PROJECT : HONOAPIILANI HIGHWAY
Kahana to Alaeloa

PROJECT NO.: F-030-1(13)

DRAINAGE

STATE OF HAWAII
DEPARTMENT OF TRANSPORTATION
LAND TRANSPORTATION FACILITIES DIVISION
DRAINAGE & IRRIGATION PLAN
HONOAPIILANI HIGHWAY
Kahana to Aiealoa
F.A. Proj. No. F-030-1(13)

Scale: As Shown Date: Sept, 1977
SHEET NO. 71 OF 8 SHEETS

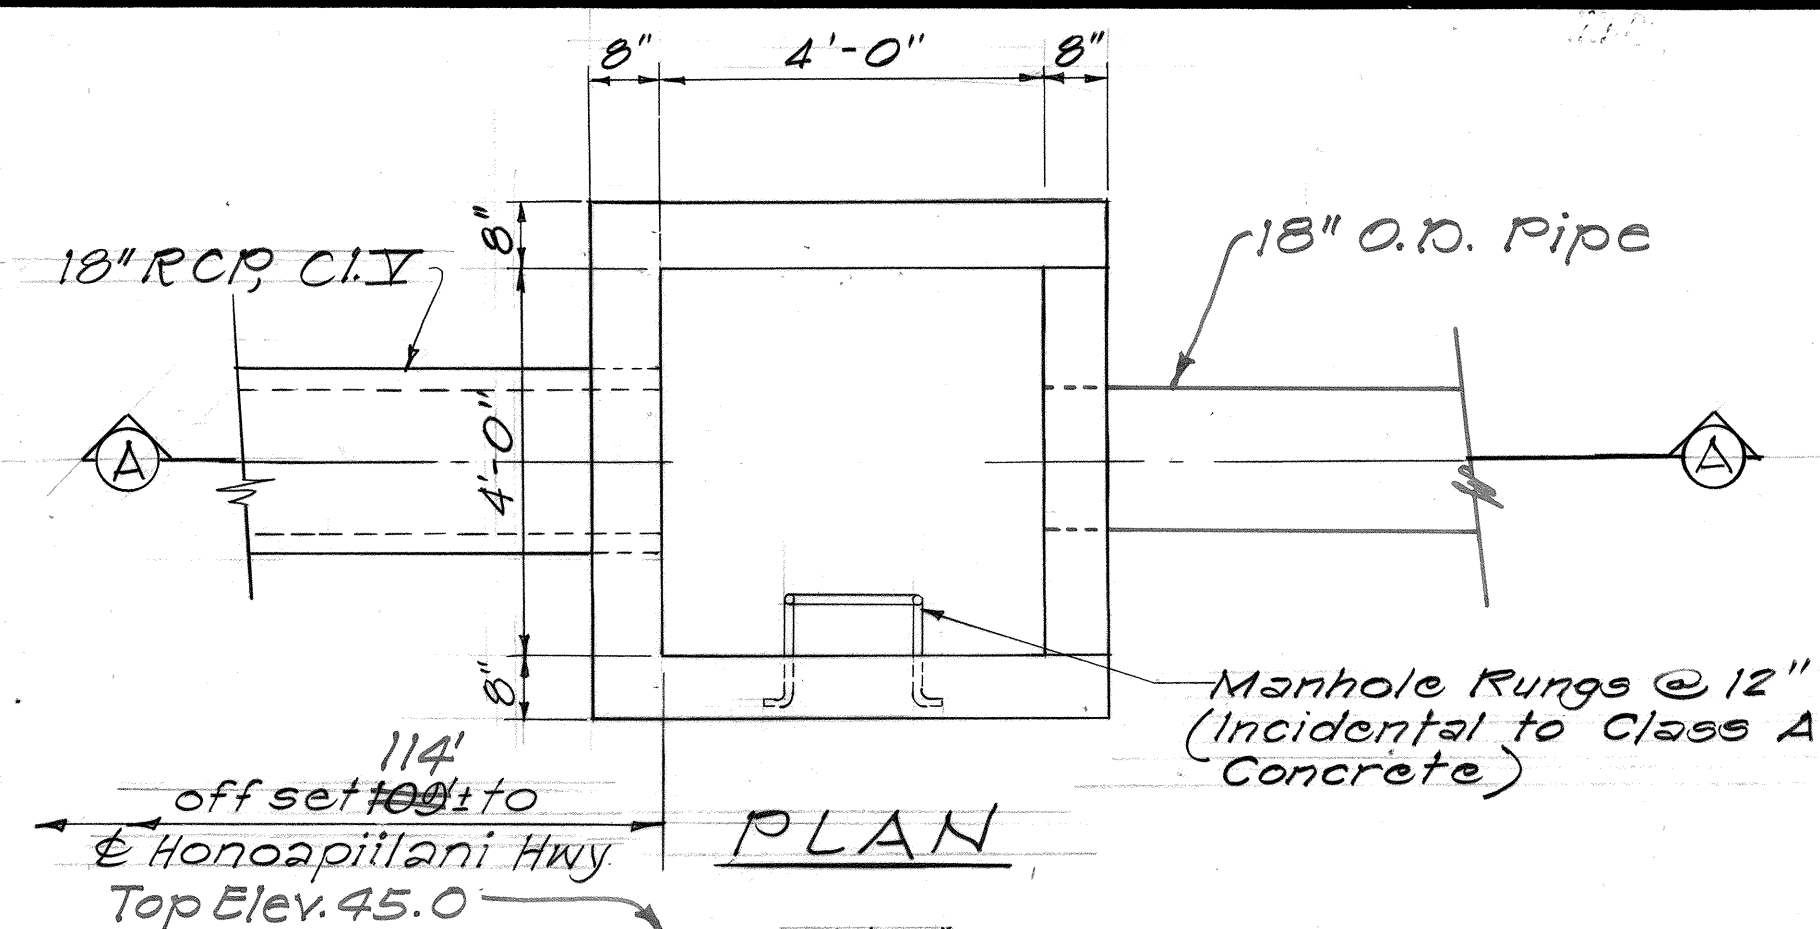
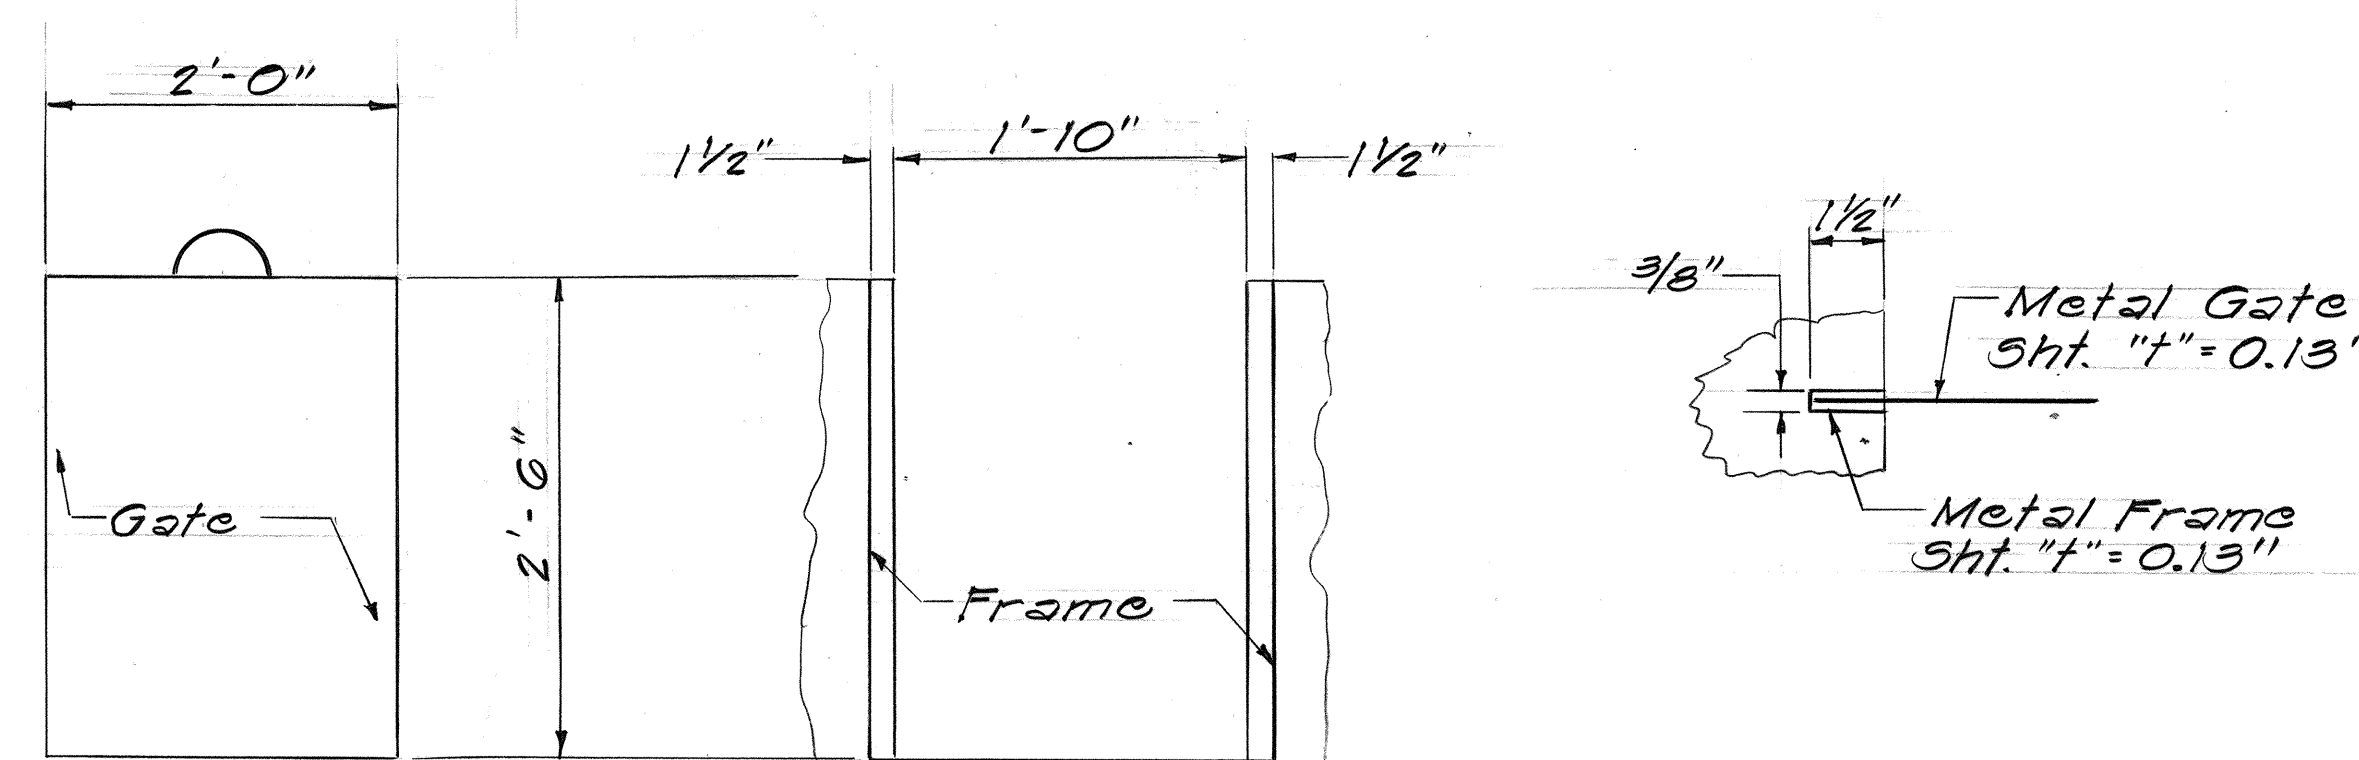
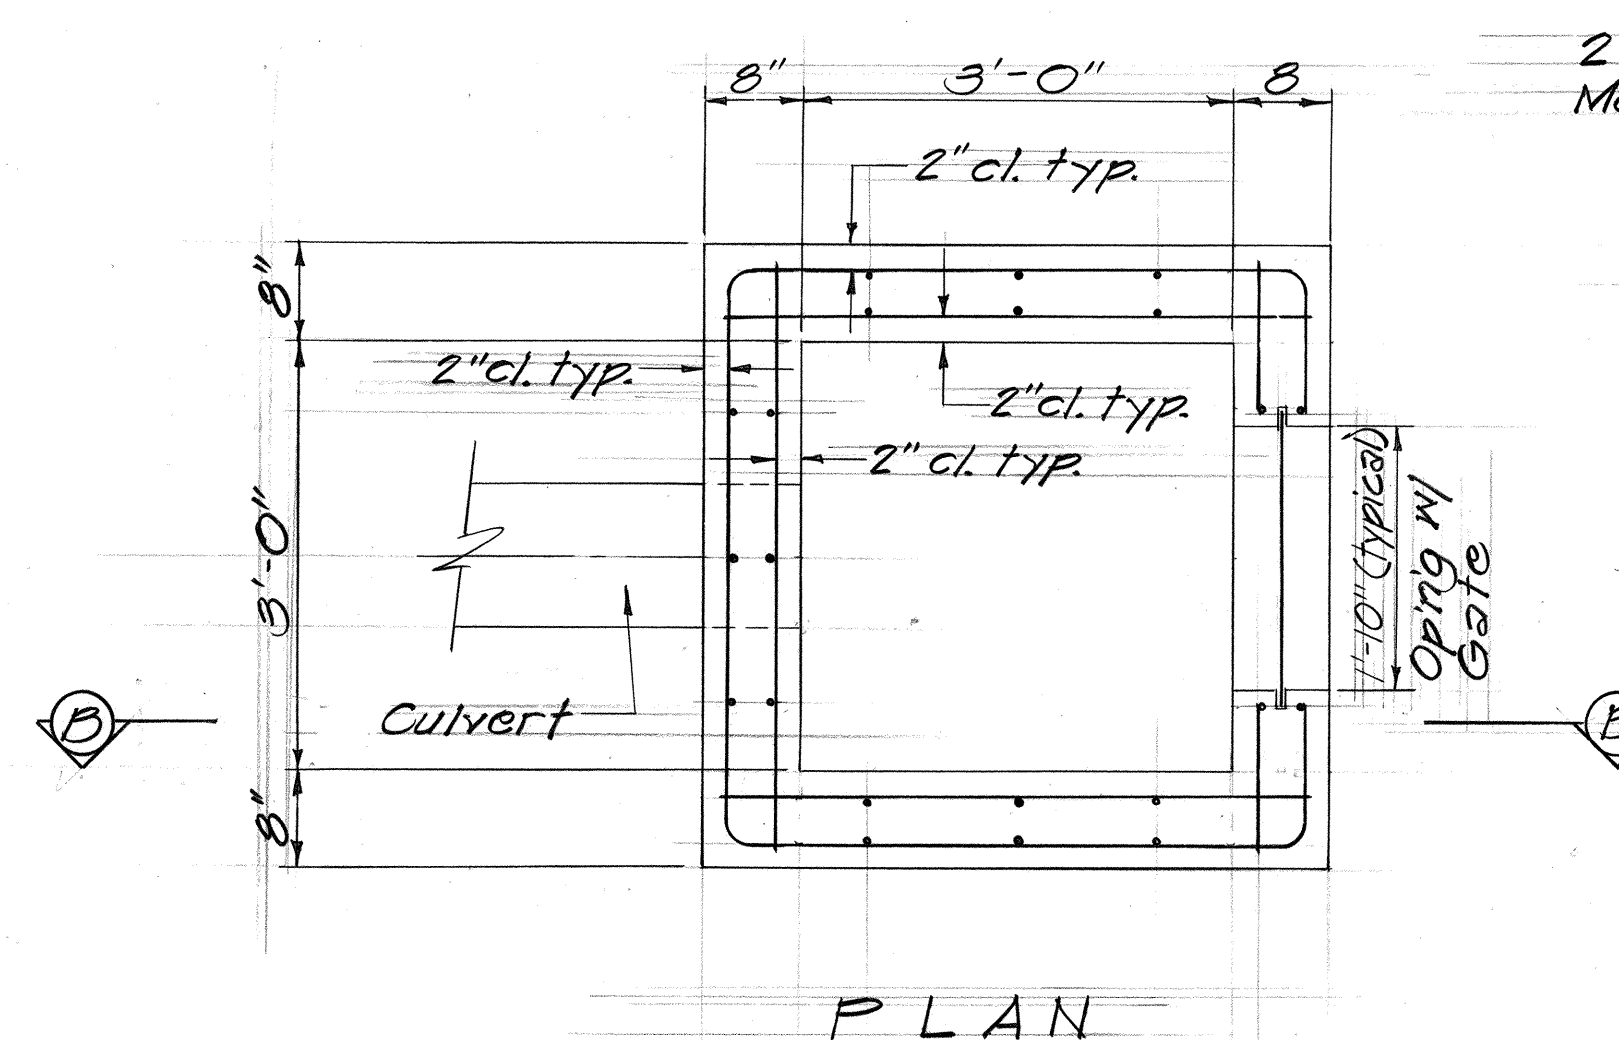
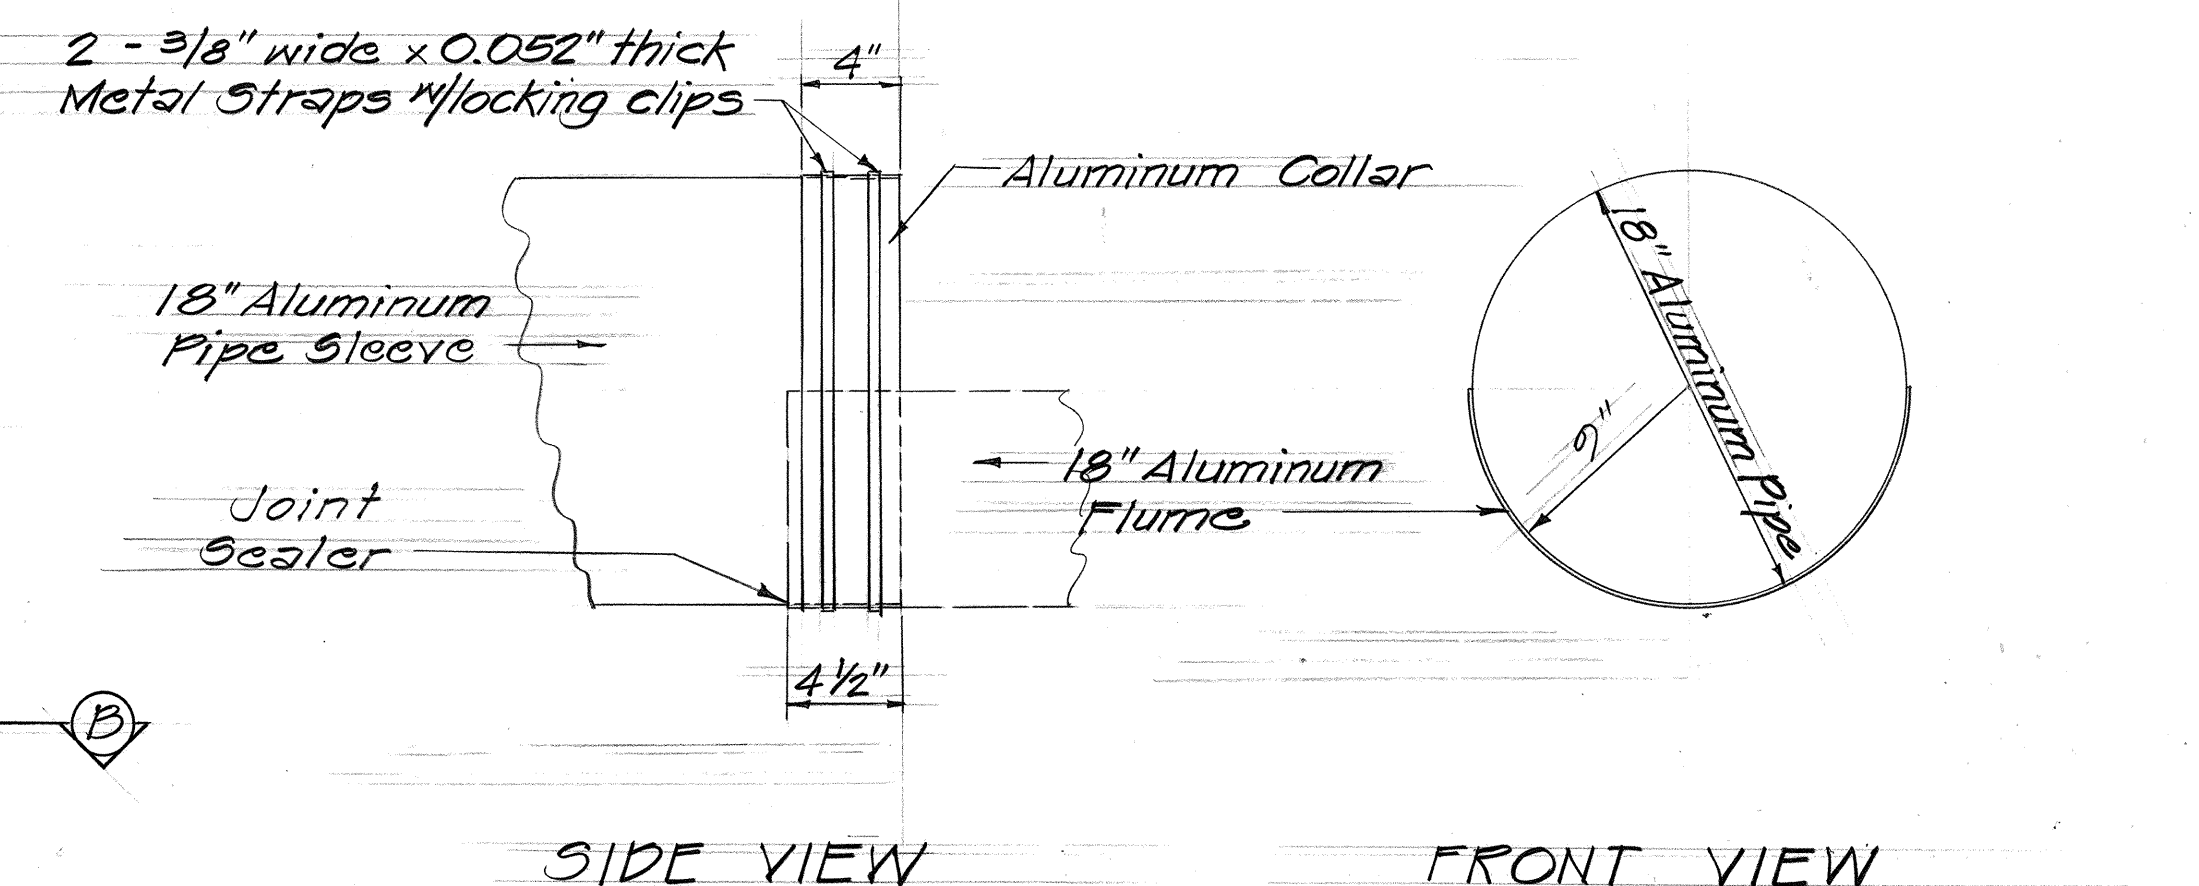
13 Nov '79 Tracing revised to show detail of box at Sta. 128+05 ± 0/5109 RT. Delete 24" siphon pipes and boxes at Sta. 119+00

SHEET No. 81 OF 8 SHEETS

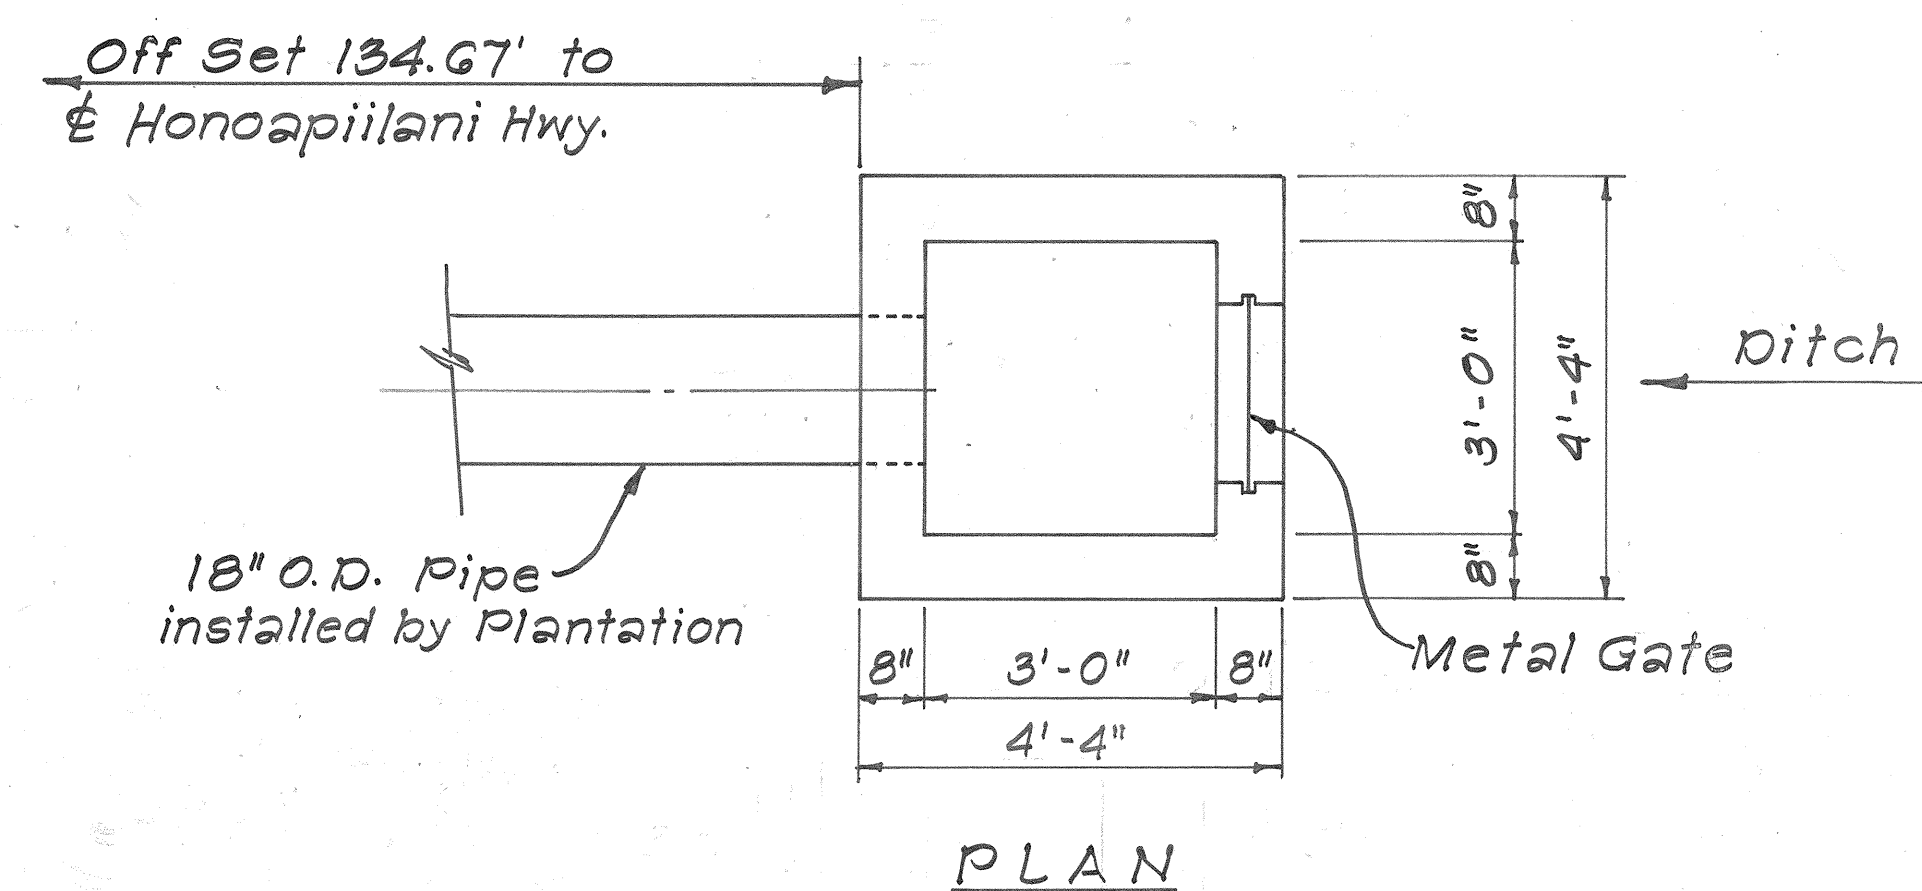
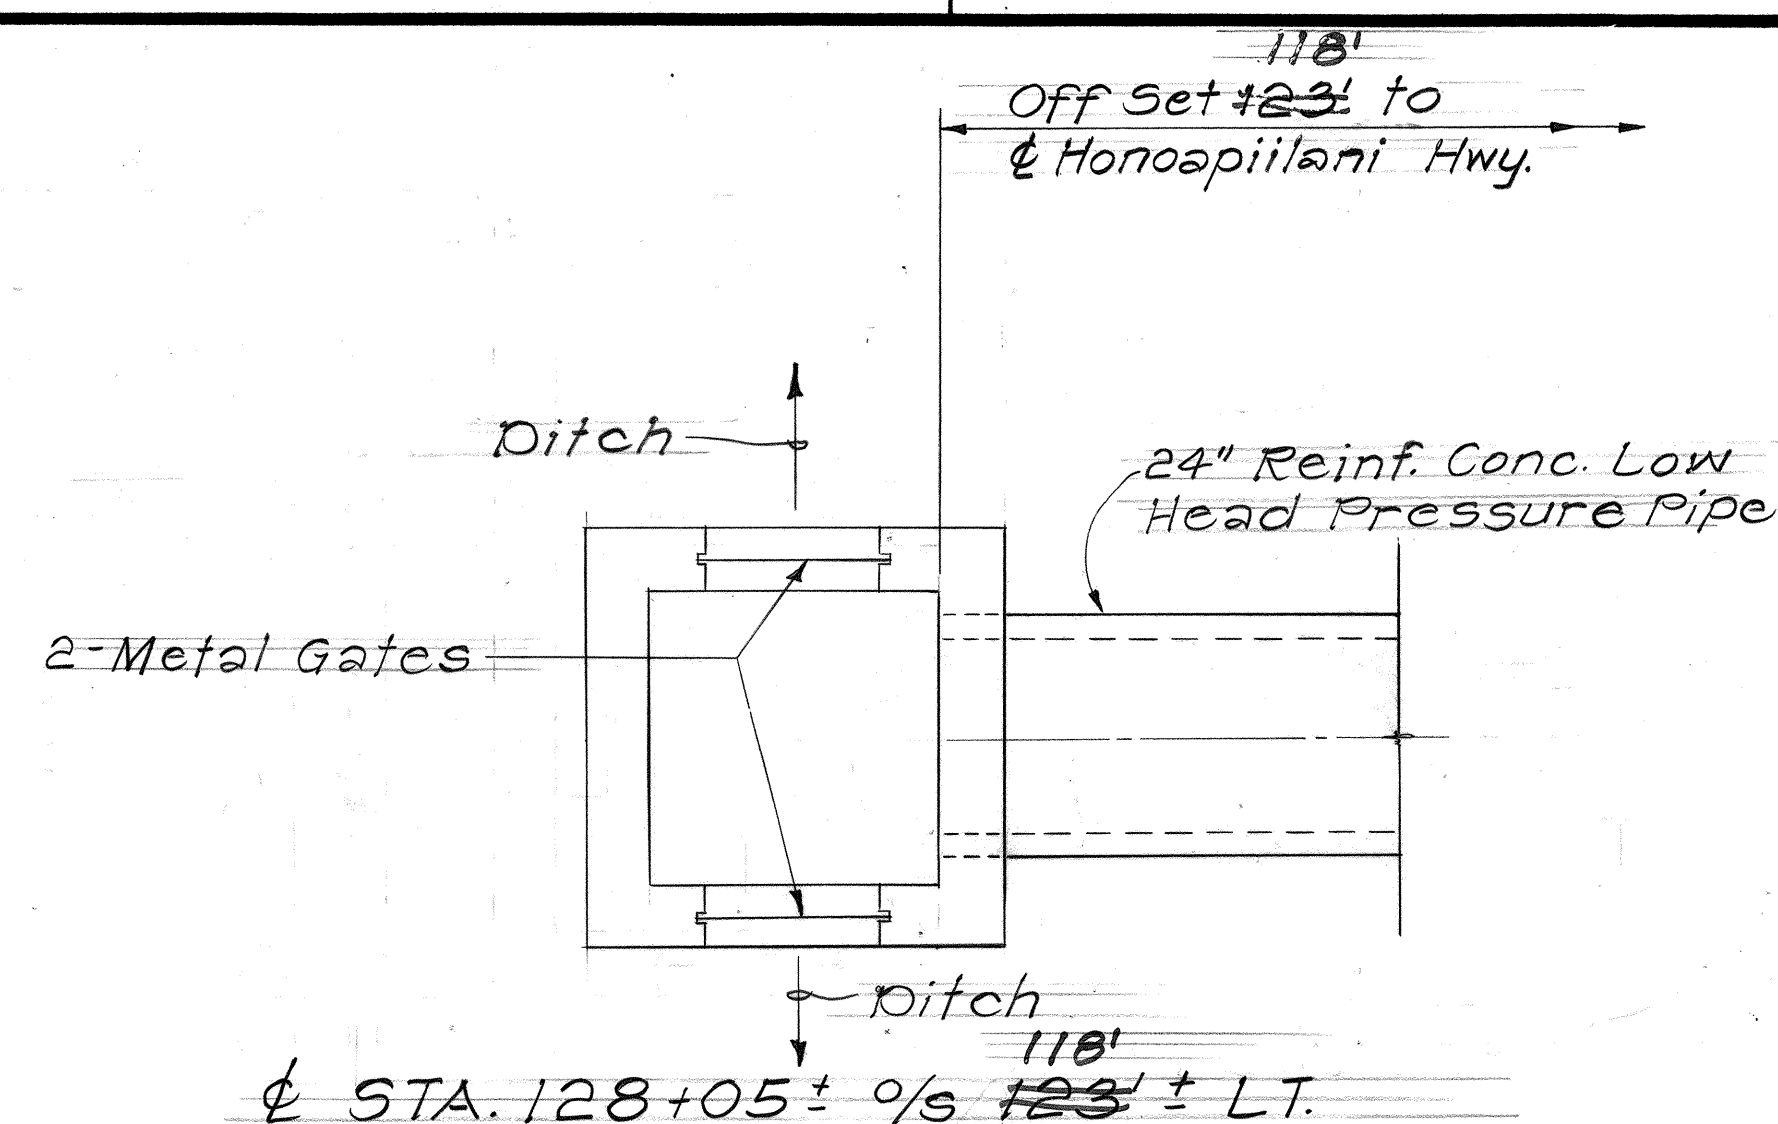
13 Nov '70	Tracing revised to show detail of box at Sta. 128+05%±123' LT.
DATE	REVISION
